MILITARY SPECIFICATION

VOLTAGE CONVERTER: 9360839

This amendment forms a part of Military Specification MIL-V-70579B (AR), dated 27 August 1990, and is approved for use by the U.S. Army Armament, Munitions, and Chemical Command, and is available for use by all Departments and Agencies of the Department of Defense.

Figure 1. Burn-in Temperature Versus Time Diagram

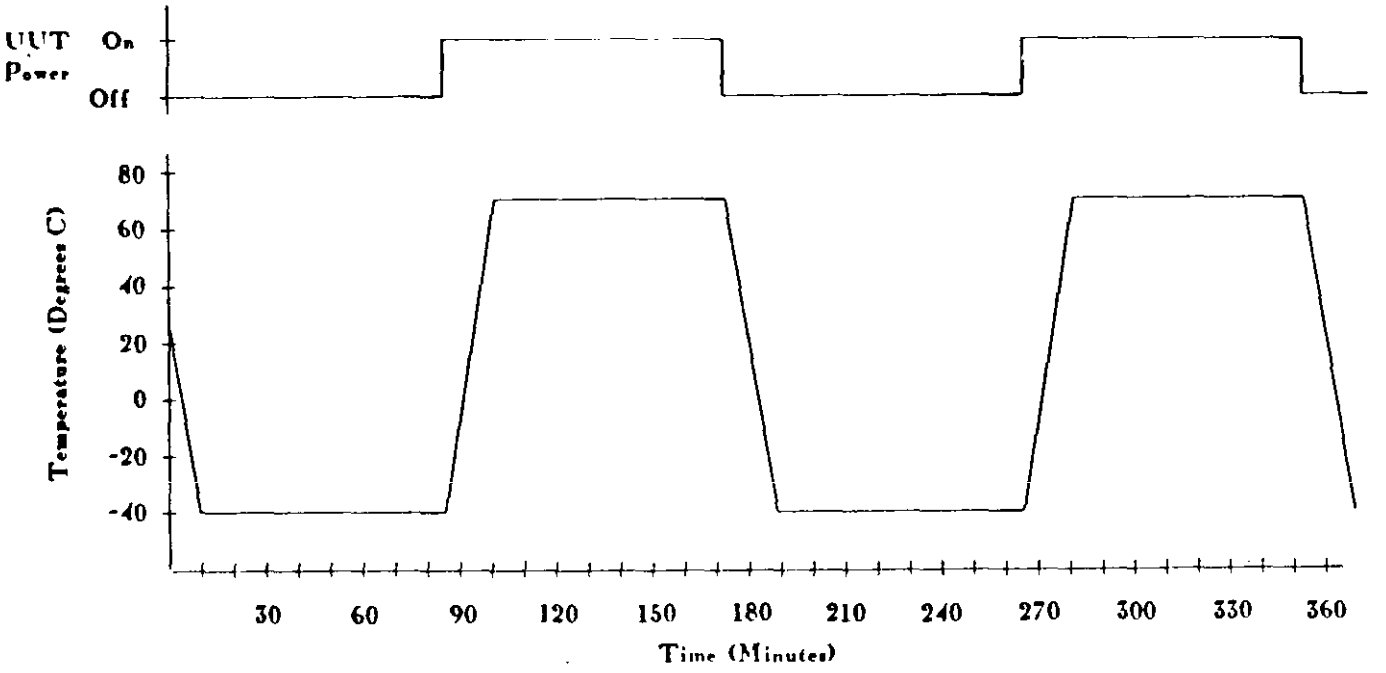
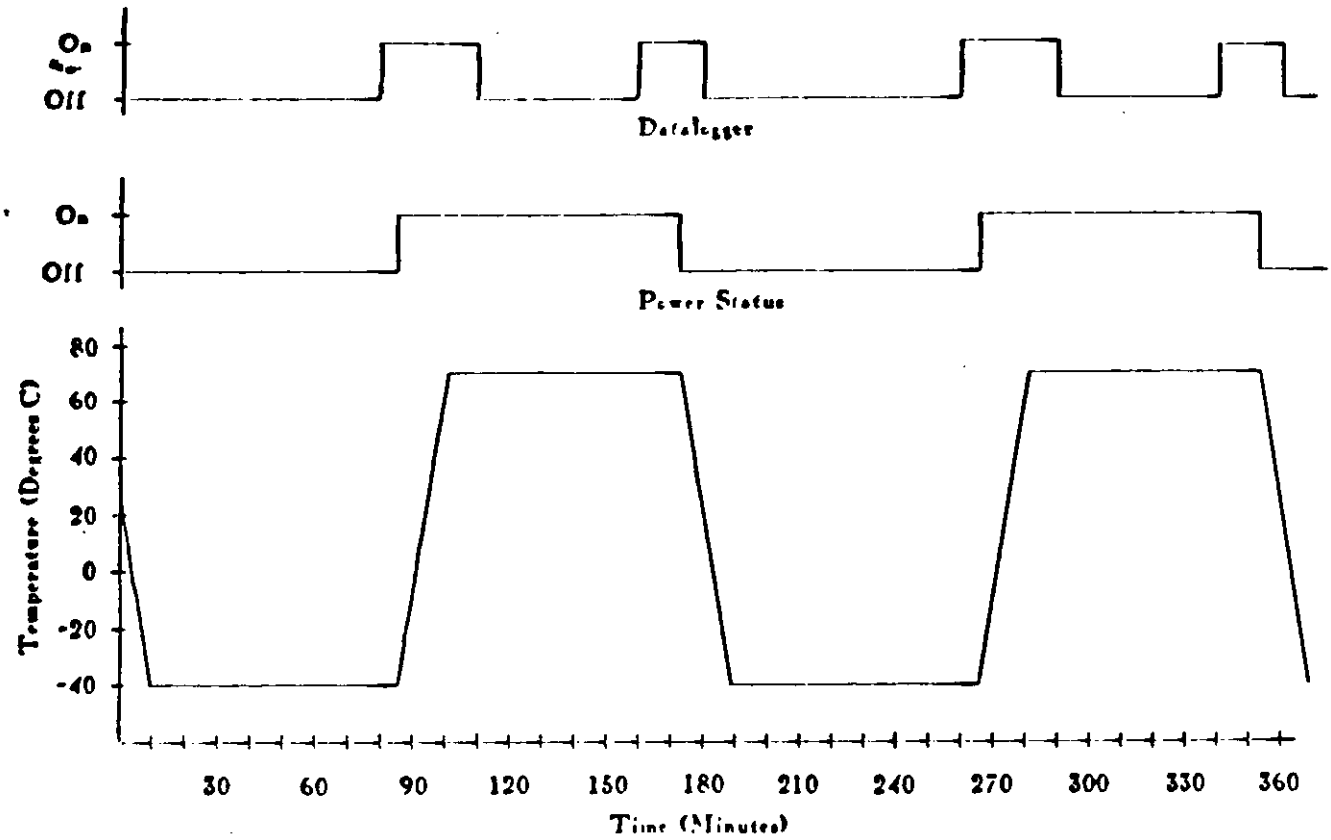
PAGE 12

Change from:

To:
